ADDENDUM NO. 4

BRACKISH WATER DESALINATION PROJECT P.W. 694

ISSUED November 10, 2020

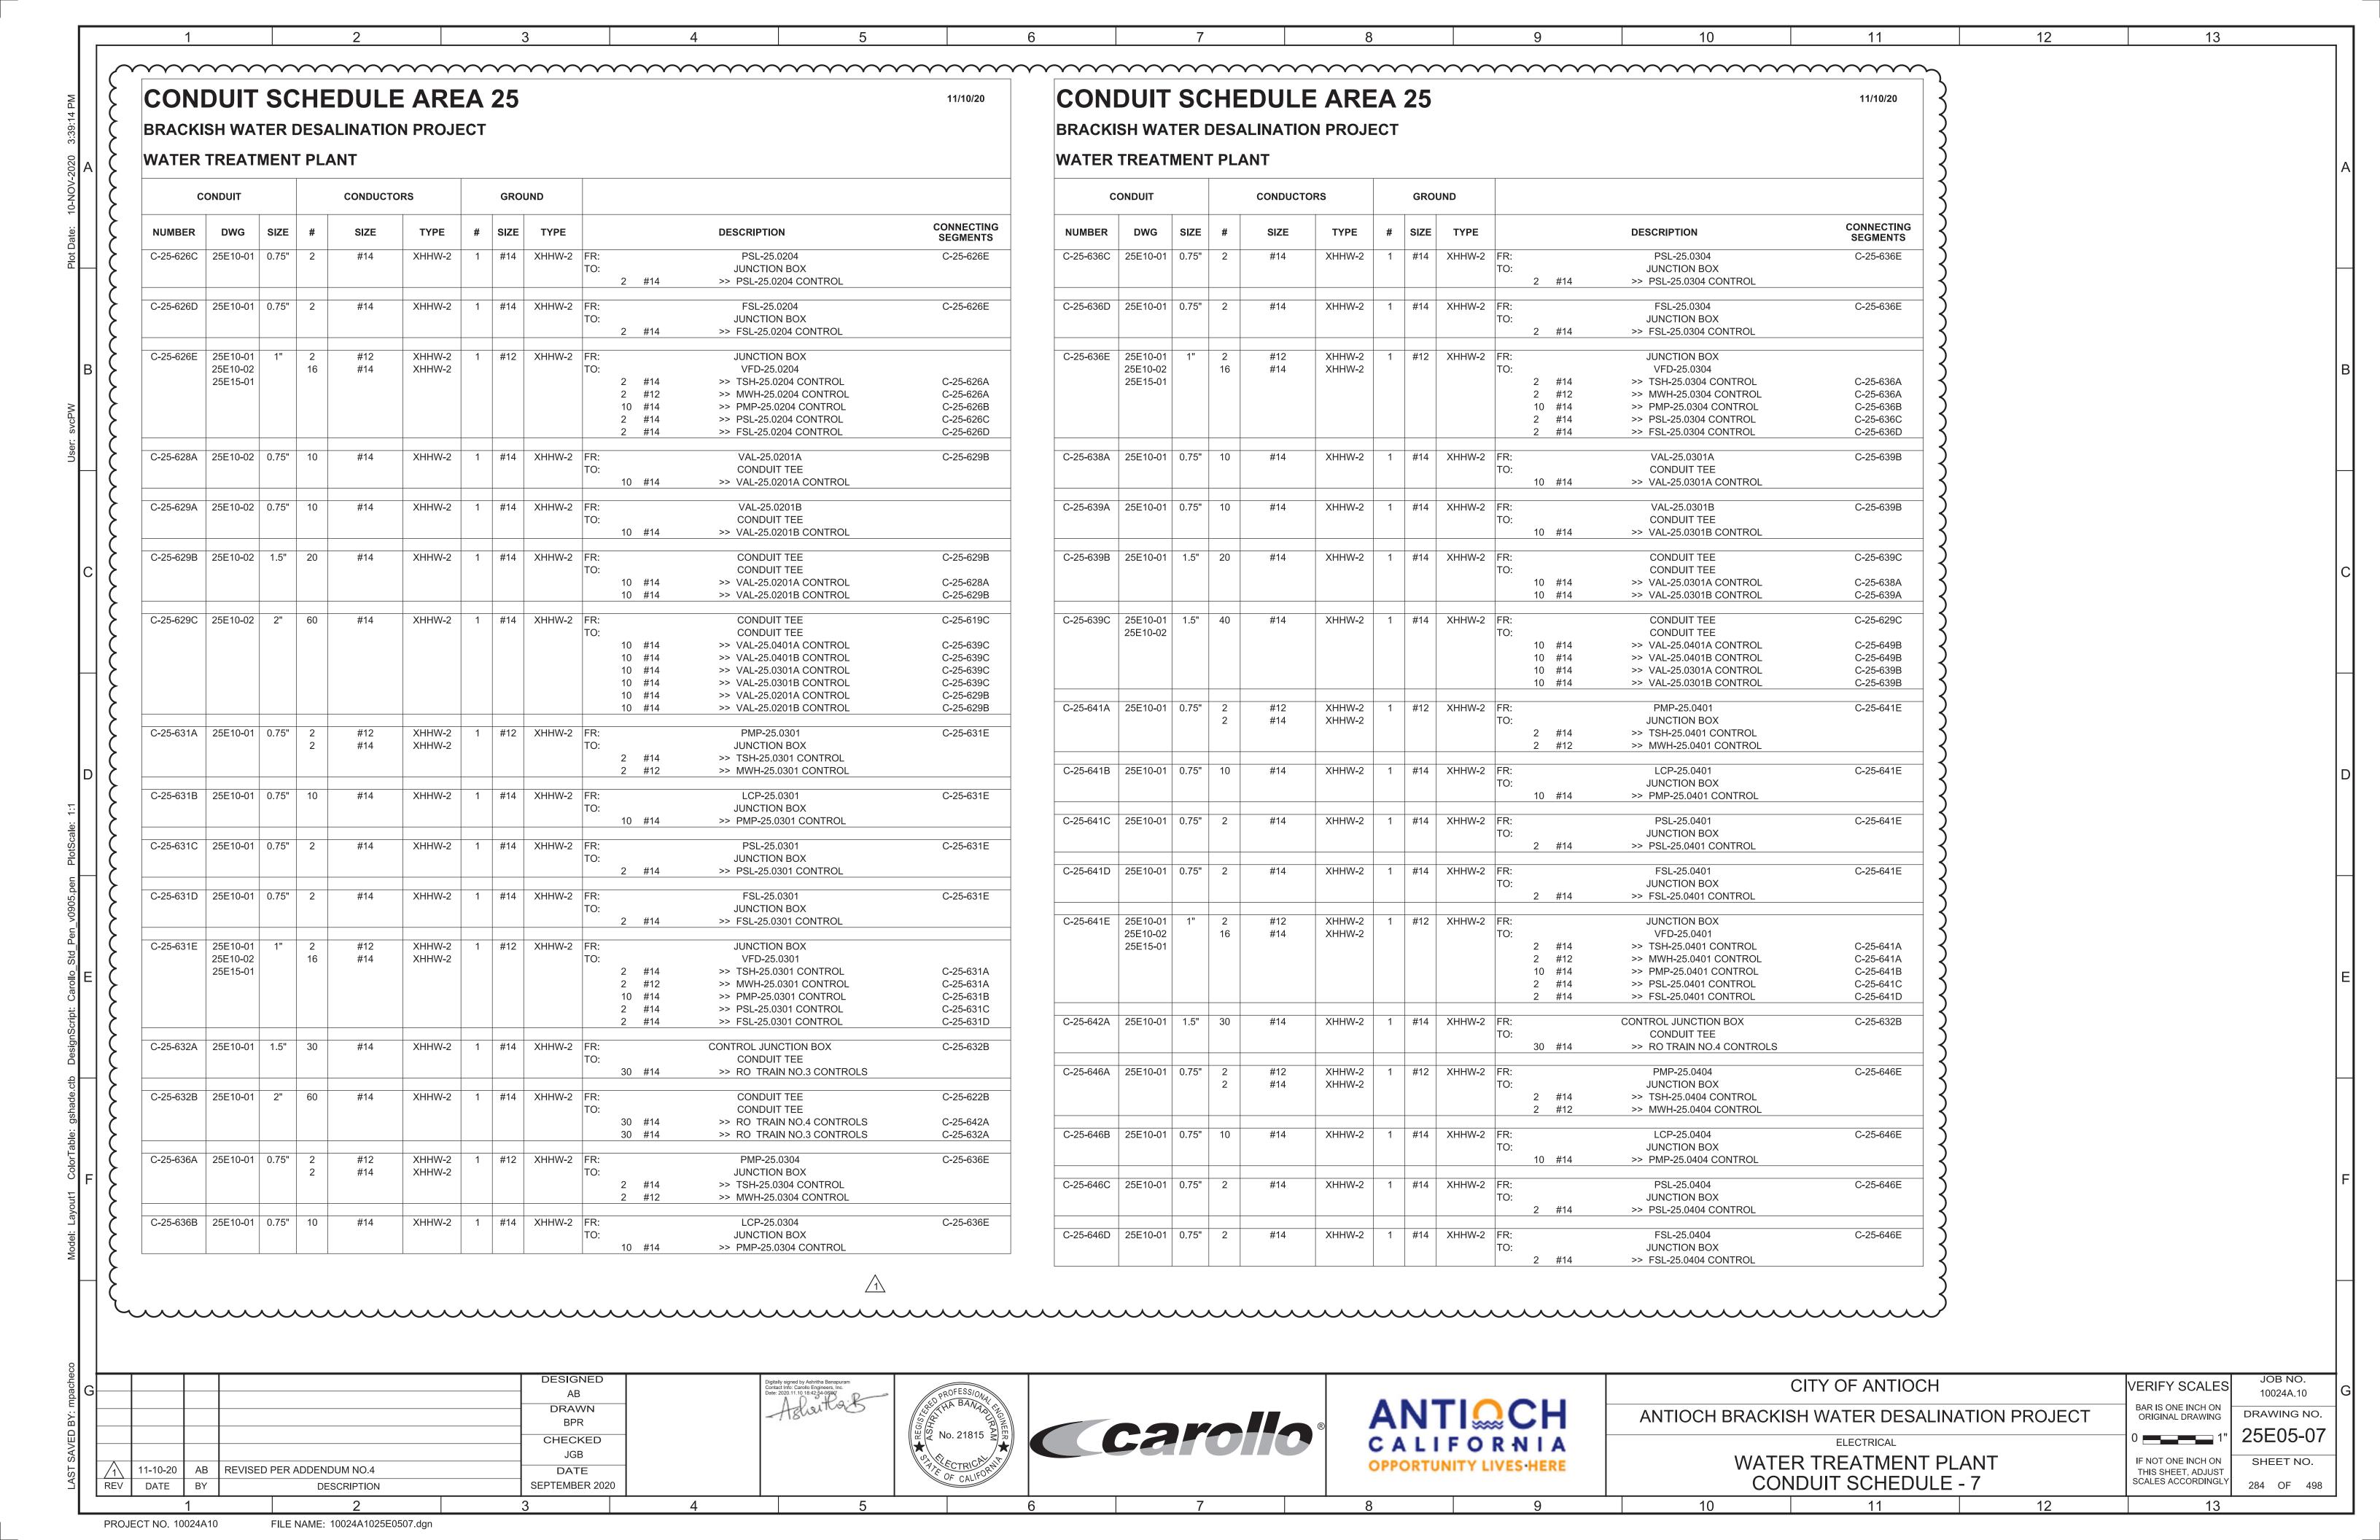
В	RACK	ISH W		ESAL	DULE INATION IT						11/10/20	CONE BRACKIS WATER 1	SH W	ATER DE	SALINAT			25				11/10/20				
	C	CONDUIT		ı	CONDUCTOR	.s	GRO	DUND				cc	ONDUIT		CONDU	CTORS		GROUND	D				}			
ı	NUMBER	DWG	SIZE	#	SIZE	TYPE	# SIZE	TYPE		DESCRIPTION	CONNECTING SEGMENTS	NUMBER	DWG	SIZE	# SIZE	TYPE	E # S	SIZE	TYPE		DESCRIPTION	CONNECTING SEGMENTS	}			
C	C-25-184C	25E01-0		80 19	#14 2/CS-#16	XHHW-2	1 #14	XHHW-2	FR: TO: 10 #14	JUNCTION BOX PCM-25.0001 >> VAL-24.0602B CONTROL	S-25-167B	C-25-214A	25E01-0	0.75"	10 #14	XHHW	7-2 1	#14 X	(HHW-2 FR TO	: :: 10 #14	G-25.0004E JUNCTION BOX >> G-25.0004E CONTROL	C-25-214B	}			
									2 2/CS-#16 1 2/CS-#16 10 #14	>> VAL-24.0602B SIGNAL >> FIT-24.0604B SIGNAL >> VAL-24.0604B CONTROL	S-25-167B S-25-167B S-25-167B	C-25-214B	25E01-0		20 #14 1 2/CS-# ²		Y-2 1	#14 X	(HHW-2 FR	:	JUNCTION BOX PCM-25.0001		}			
									2 2/CS-#16 10 #14	>> VAL-24.0604B SIGNAL >> VAL-24.0604A CONTROL	S-25-167B S-25-167B		25E10-0		2/03-#	0				10 #14 10 #14	>> G-25.0004A CONTROL >> G-25.0004E CONTROL	C-25-210A C-25-214A	}
